Please amend the title of the invention as “Sequence Lighting System for Footwear”

Annotated Marked-up-Drawings

FIG.1

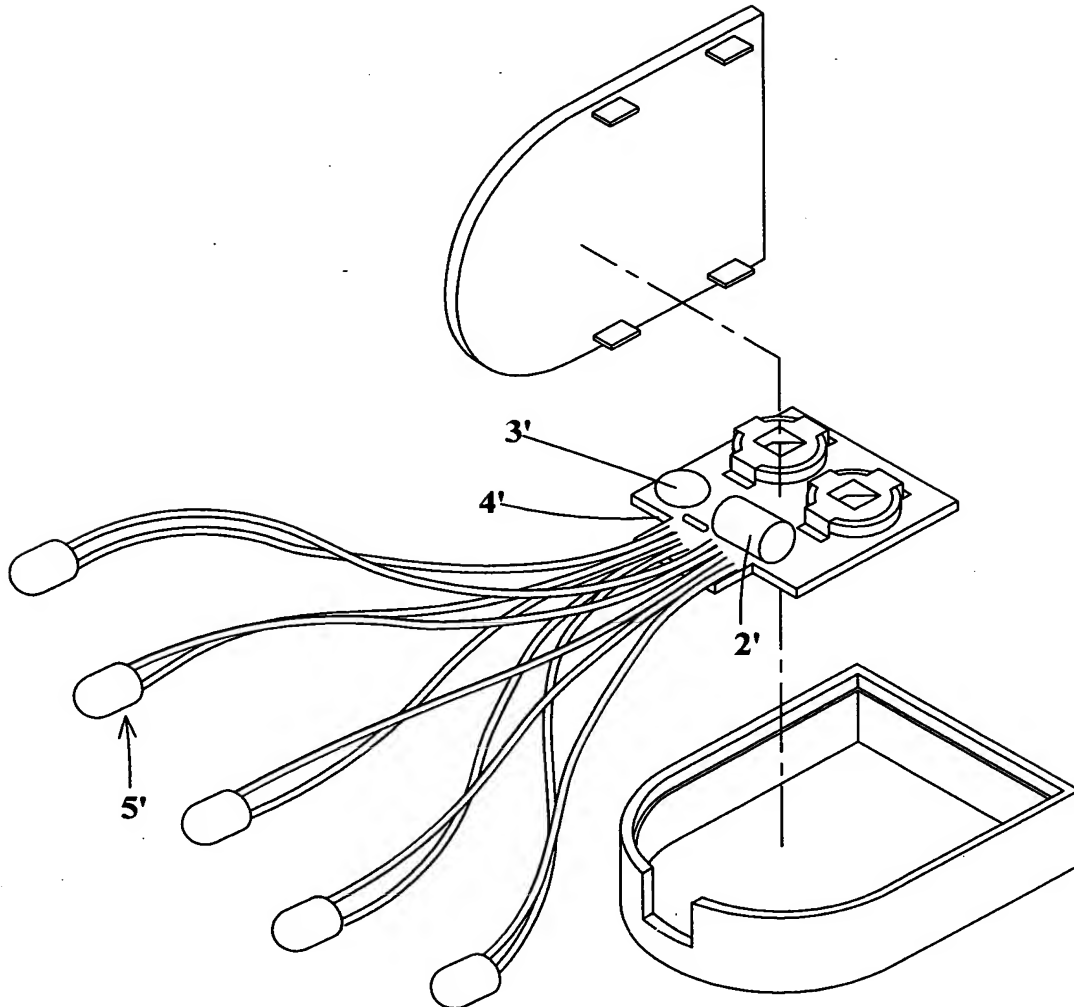
Please amend the Fig. 1 as the attached amended copy. In the amendment of the figure, the figure is added with “Prior Art”. No other portion is amended. Thereby, no new matter is added.
